**IRONHOUSE SANITARY DISTRICT**

SUBJECT: Comments on Tentative Waste Discharge Requirements for the Ironhouse Wastewater Treatment and Recycling Facility

IRONHOUSE SANITARY DISTRICT COMMENTS  
ON  
TENTATIVE WASTE DISCHARGE REQUIREMENTS  
FOR  
IRONHOUSE SANITARY DISTRICT  
IRONHOUSE WASTEWATER TREATMENT AND RECYCLING FACILITY  
CONTRA COSTA COUNTY

**MAINLAND FACILITIES SITE PLAN**

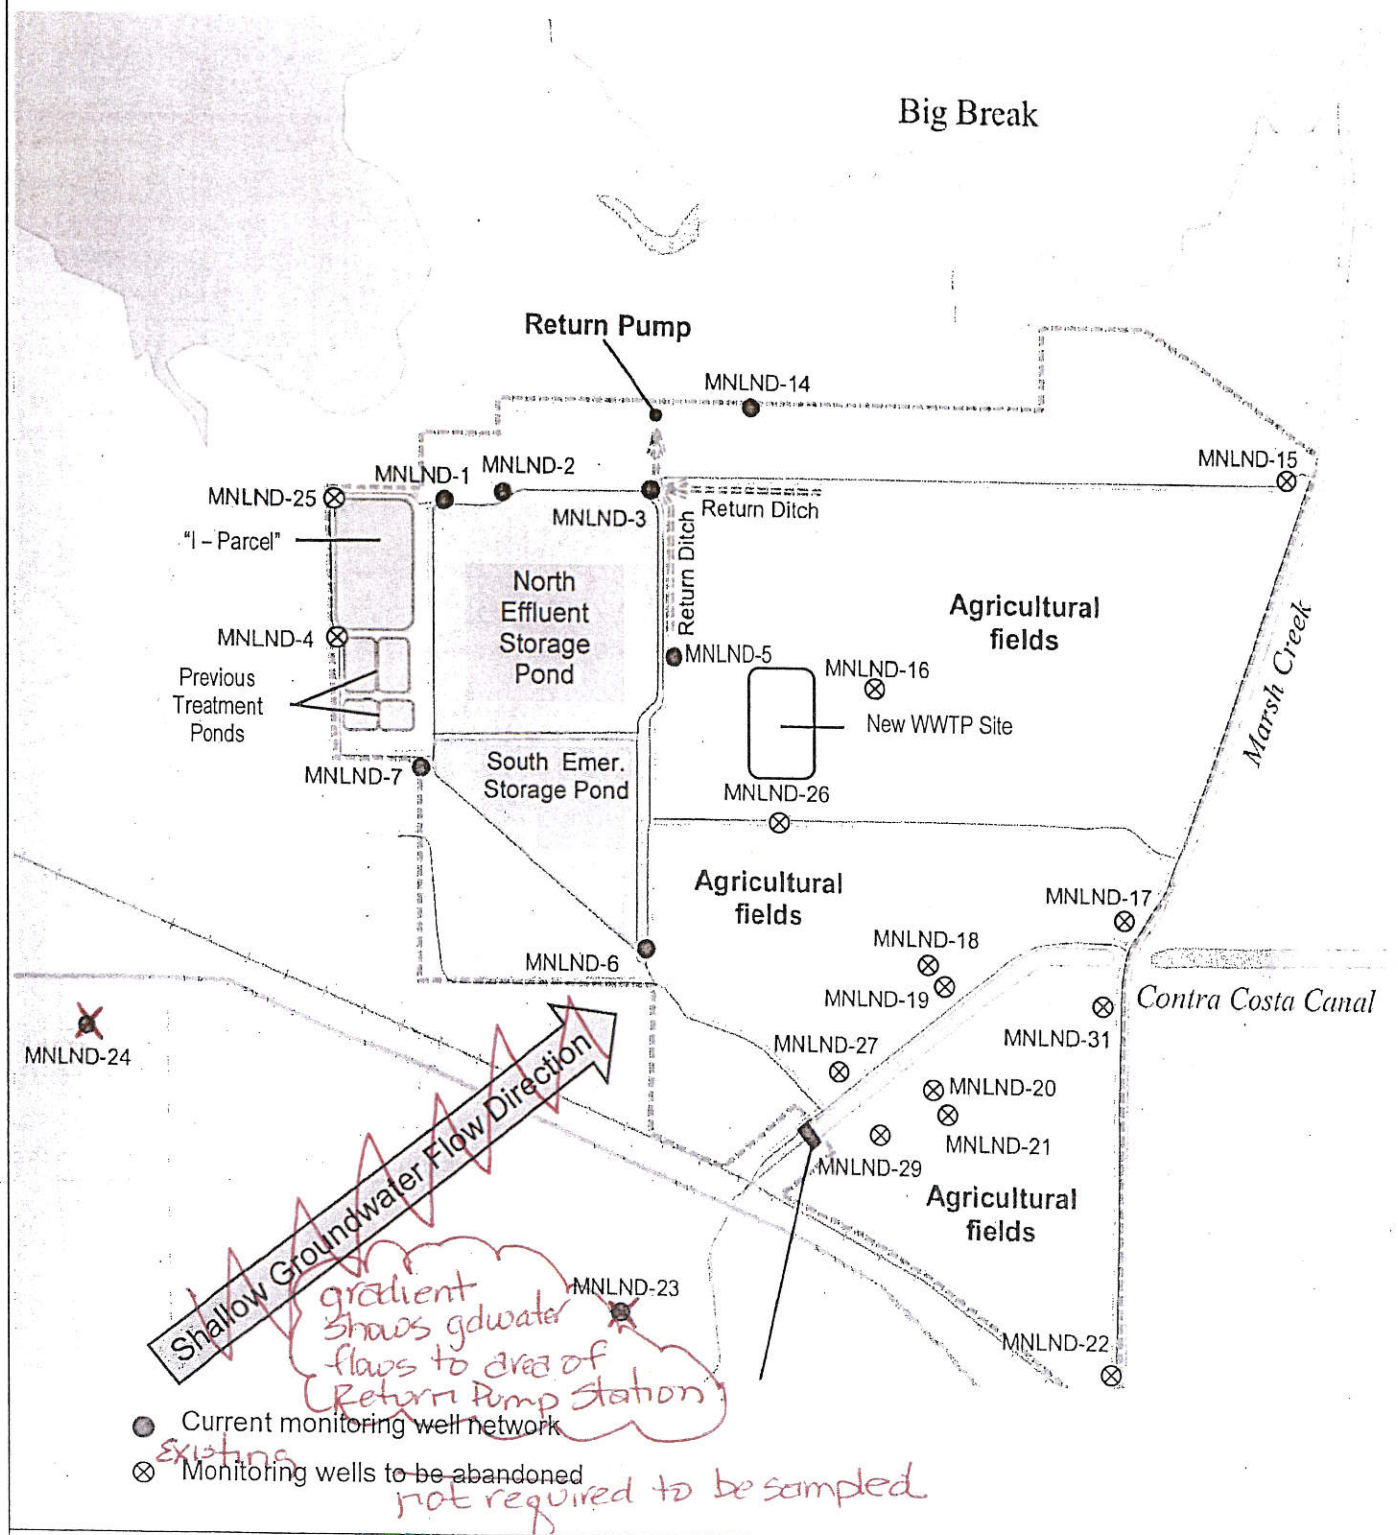
p. 5, 2 <sup>nd</sup> para.	...the destruction of abandoned wells <u>on the mainland</u> ...
<b>Attachments</b>	
Attachment A	Locations of Supply Pump Station, Return Pump Station, and "I" Parcel need to be labeled per markup of figure provided as an attachment to these comments.
Attachment B	"Monitoring wells to be abandoned" needs to be replaced with "Existing wells not required to be sampled." In addition, the arrow showing the shallow groundwater gradient needs to be deleted.
